CONSUMER PRODUCT SAFETY COMMISSION

16 CFR Part 1270

Safety Standard for Adult Portable Bed Rails

ACTION: Notice of proposed rulemaking; notice of opportunity for oral presentation of comments.

- Section 8.4.5.4. Add the following proposed figures (Figure 4a and Figure 4b) for reference for Zone 3 test:

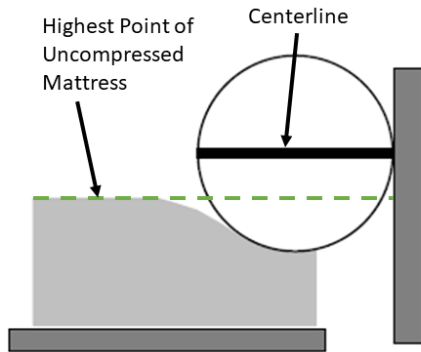
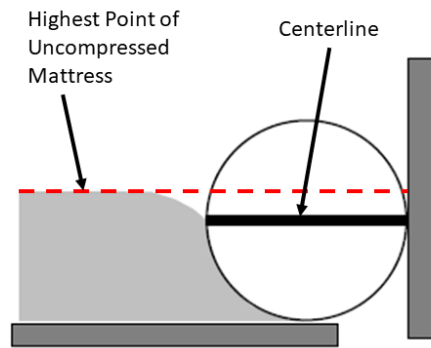
- Section 6.3.3: Zone 3—Revise “The highest point on the cylinder of the test probe (see 7.2) shall not pass completely below the horizontal uncompressed plane of the mattress when tested according to 8.4.5.” Add at the end of the sentence “...when tested in accordance with section 8.4.5, the horizontal centerline on the face of the 4.7 in (120 mm) end of the test probe (see 7.2) shall be above the highest point of the uncompressed mattress.”
- Section 8.4.5.4: Revise “Turn the cone until the centerline on the face of the 4.7 in (119.38 mm) end is horizontal and let the cone sink into the space by its own weight. (1) If the line on the face of the 4.7 in (120 mm) end of the cone is above the surface of the mattress highest point of the uncompressed mattress, as shown in Figure 4a, the space passes the test. (2) If the line on the face of the 4.7 in (120 mm) end of the cone is at or

below the surface of the mattress, the space fails the test.” Instead of the “below the surface of the mattress” insert “below the highest point of the uncompressed mattress, as shown in Figure 4b.”

CPSC staff’s review showed that the Zone 3 entrapment performance requirement in section 6.3.3 is redundant due to the failure criteria described in the associated test method, section 8.4.5.4. To ensure consistency, proposed revisions to these sections more accurately describe the test method for the highest level of safety and are also more consistent with the FDA guidance document referenced in the standard. In addition, the Figures 4a and 4b are proposed to assist testers in visualizing the test criteria.

Figure 4a: Zone 3 **Pass** Criteria
(Centerline **above** highest point of uncompressed mattress)

Figure 4b: Zone 3 **Fail** Criteria
(Centerline **below** highest point of uncompressed mattress)

Figure 1 to paragraph (b)(14) of this section: Zone 3 test: (a) Pass, (b) Fail

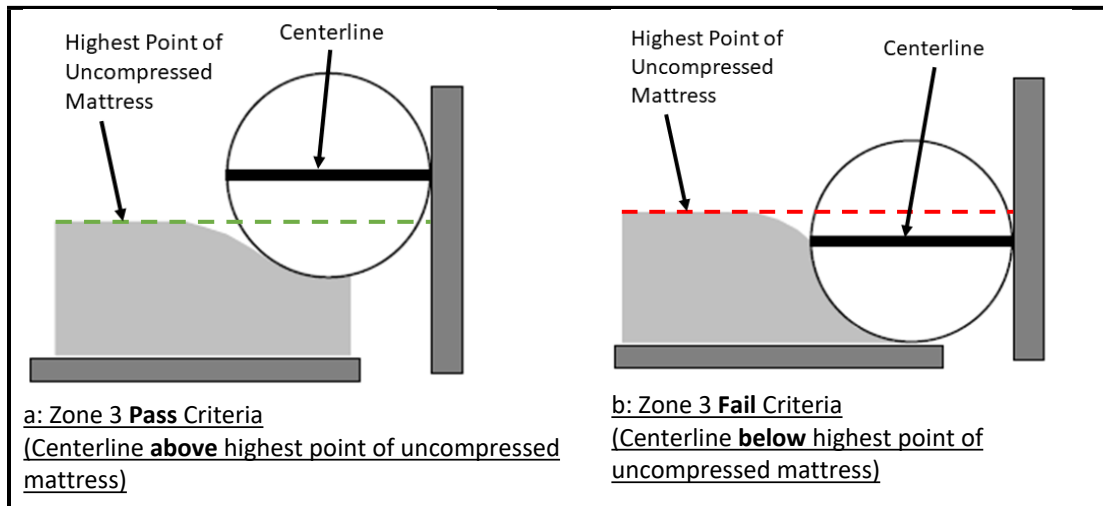
(A) If the line on the face of the 4.7 in (120 mm) end of the cone is above the highest point of the uncompressed mattress, as shown in Figure 1 to paragraph (b)(14) of this section, the space passes the test.

(B) If the line on the face of the 4.7 in (120 mm) end of the cone is at or below the highest point of the uncompressed mattress, as shown in Figure 1 to paragraph (b)(14) of this section, the space fails the test.
